Project: 201004sid-N169770 JHHIP Stage 1 SSDA report - 2036 without Dev

C. COMPLIANCE REVIEW

HEALTH INFRASTRUCTURE
JOHN HUNTER HOSPITAL NEWCASTLE
BASEMENT 01
CAR PARK COMPLIANCE REVIEW
DRAWING NO. N169772-01-02 SHEET 02 OF 12 ISSUE P3

HEALTH INFRASTRUCTURE
JOHN HUNTER HOSPITAL NEWCASTLE
SOUTHERN PICK-UP/ DROP-OFF AREA AND BUS LAYOUT
COMPLIANCE REVIEW
DRAWING NO. N169772-02-01 SHEET 01 OF 05 ISSUE P3

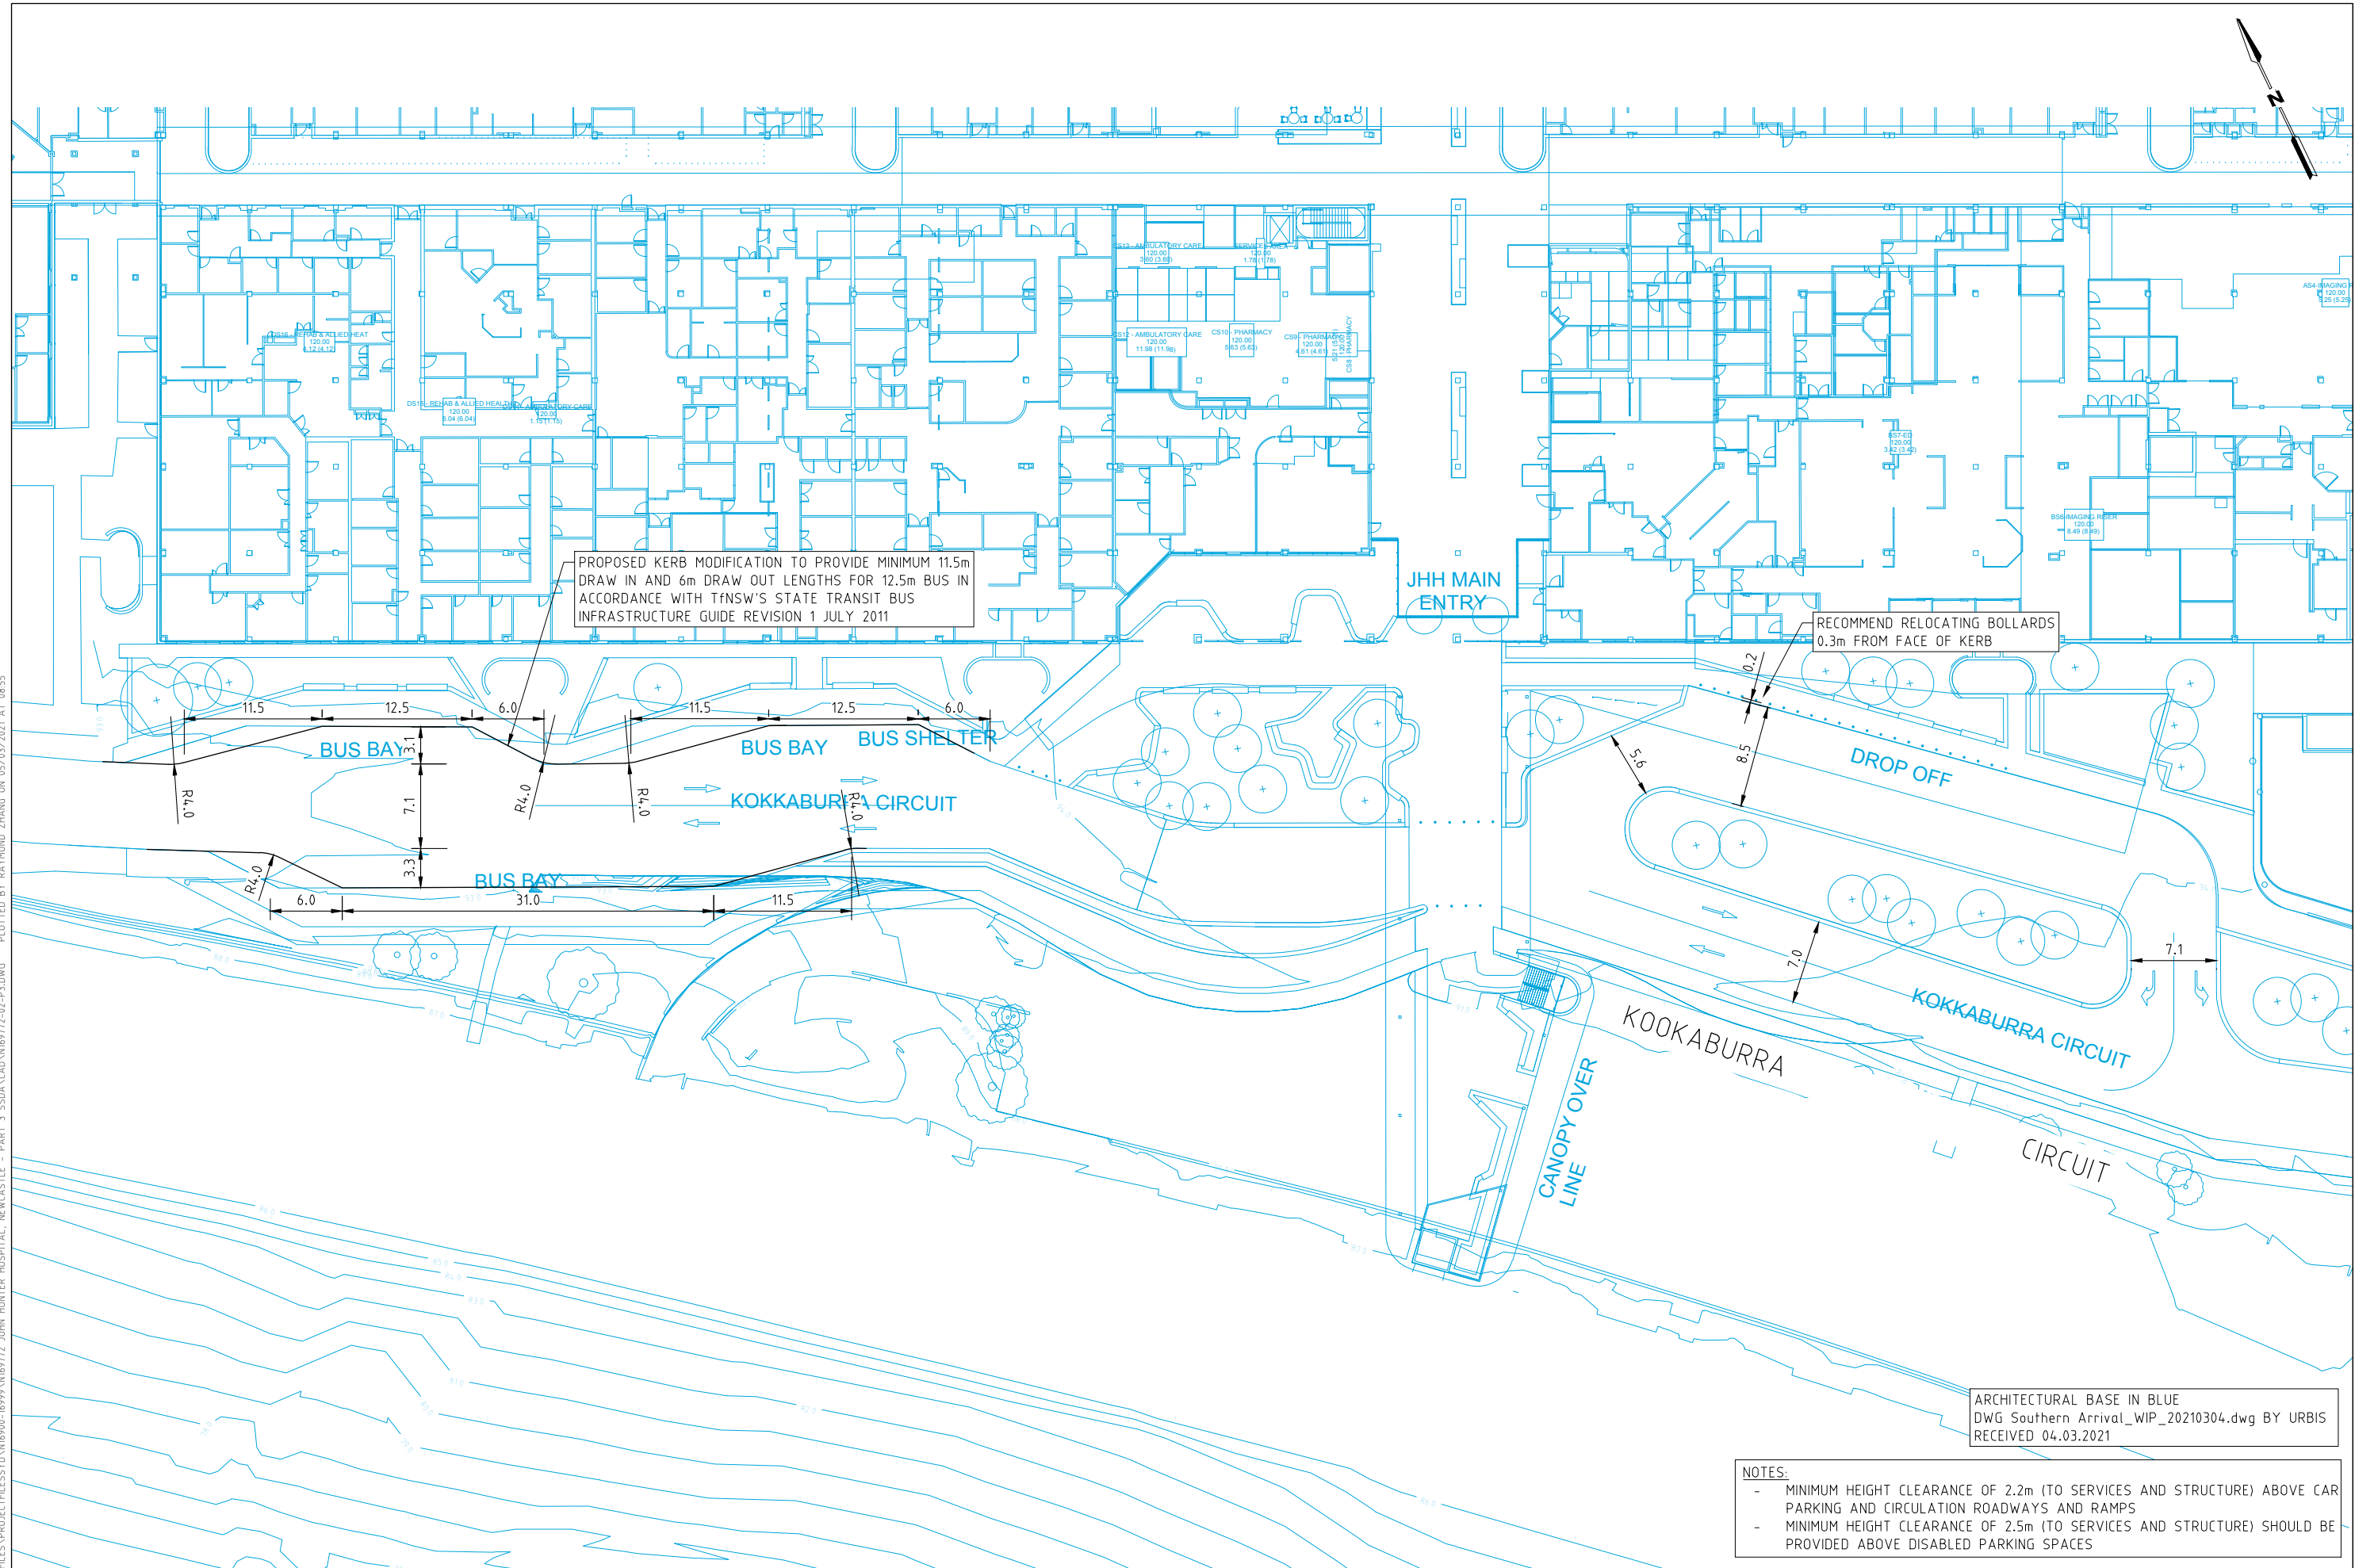
PROPOSED KERB MODIFICATION TO PROVIDE MINIMUM 11.5m DRAW IN AND 6m DRAW OUT LENGTHS FOR 12.5m BUS IN ACCORDANCE WITH TfNSW'S STATE TRANSIT BUS INFRASTRUCTURE GUIDE REVISION 1 JULY 2011
